AMENDMENT 1 AMENDEMENT 1

**Electric motor-operated hand-held tools, transportable tools and lawn and garden machinery – Safety –
Part 3-1: Particular requirements for transportable table saws**

Amendment 1 to IEC 62841-3-1:2014 has been prepared by IEC technical committee 116: Safety of motor-operated electric tools.

Figure 114 – Minimum distance from the front edge of the table top to the front edge of the saw blade guard

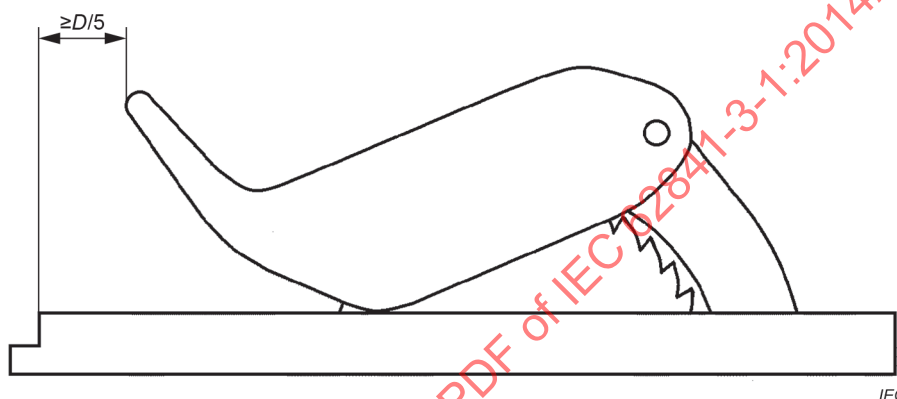
Replace the existing Figure 114 with the following new figure:
